SANDSPIT
HOLIDAY
PARK

WASTEWATER SYSTEM INVESTIGATION

PROPOSED IRRIGATION AREA

Figure: 1

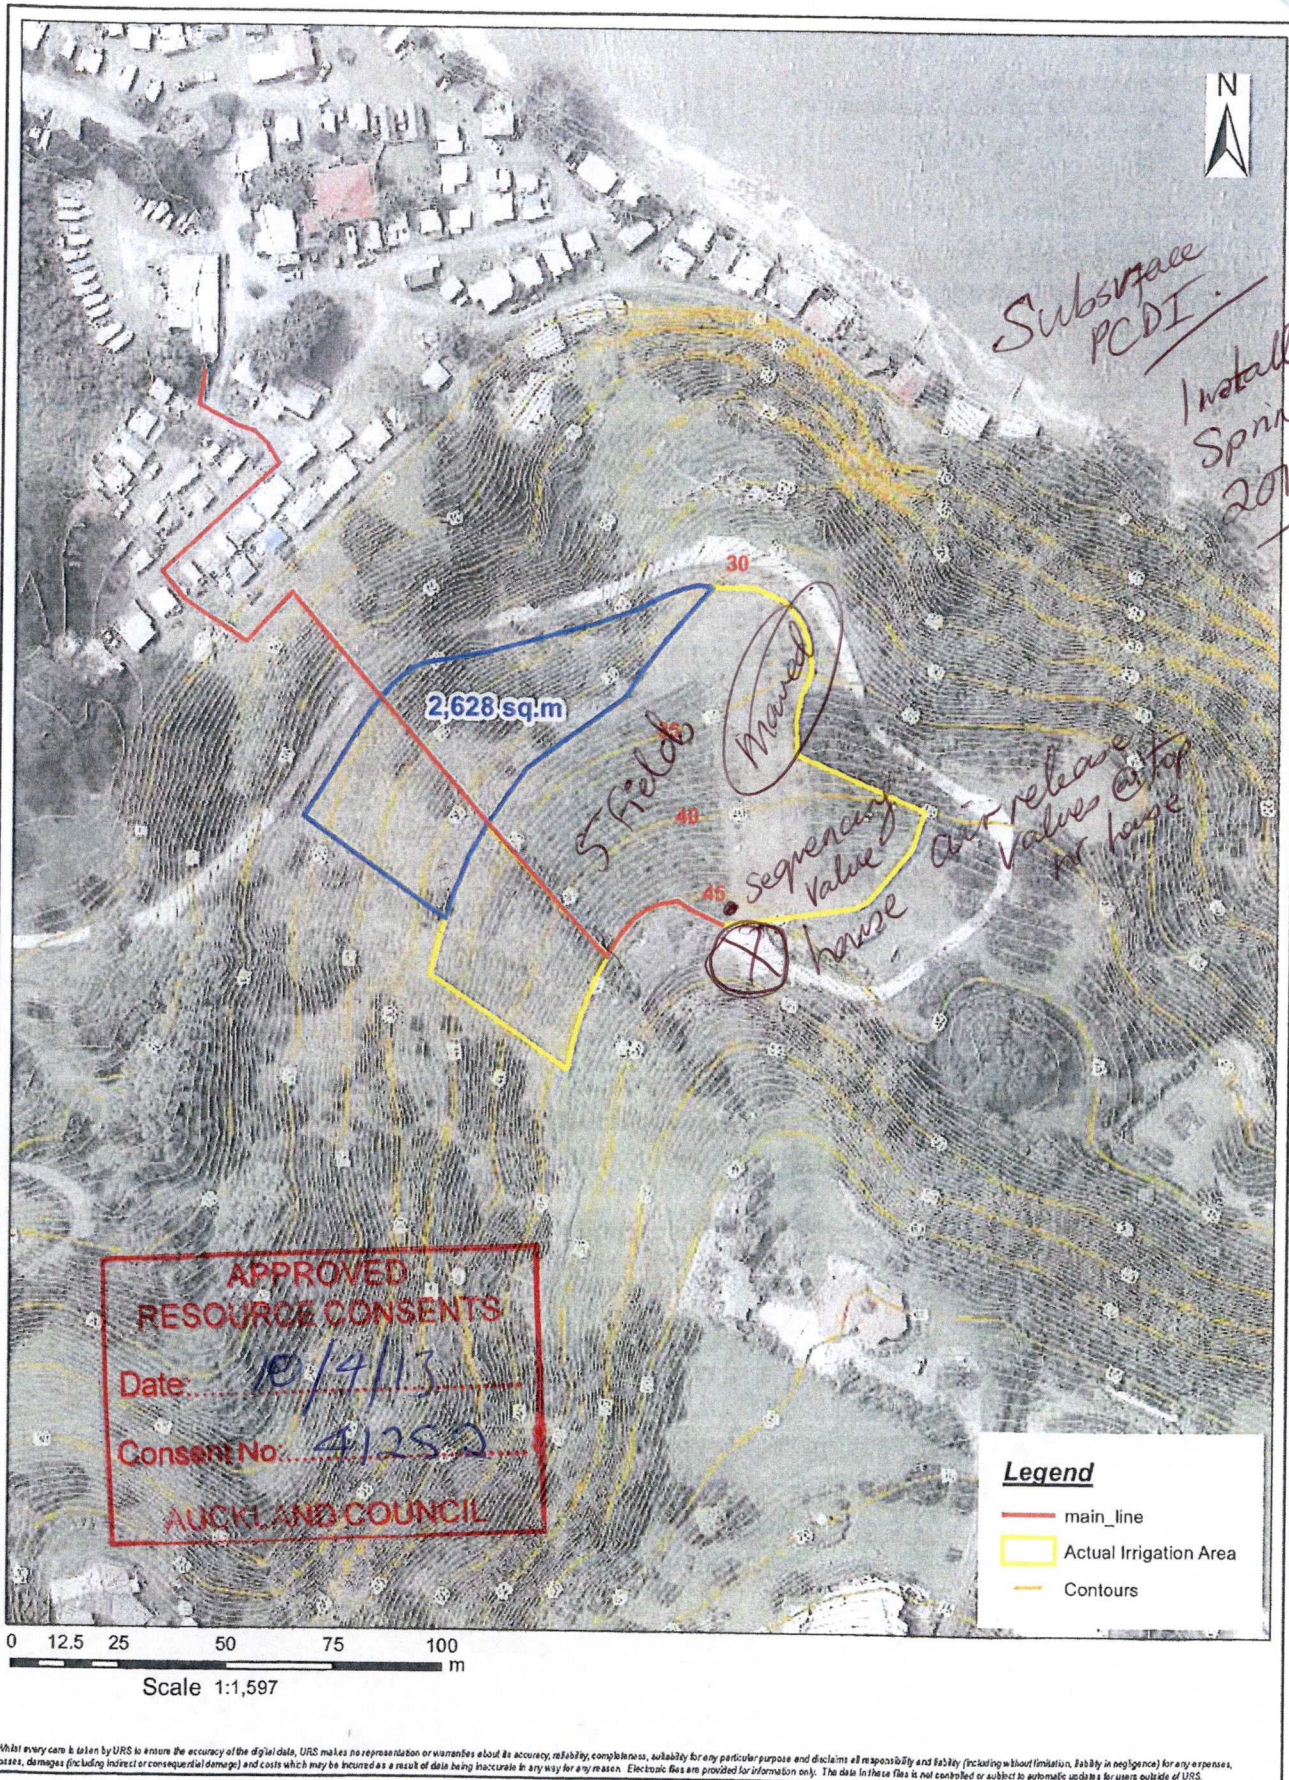
distance
to estuary or
this flow path
from TP?
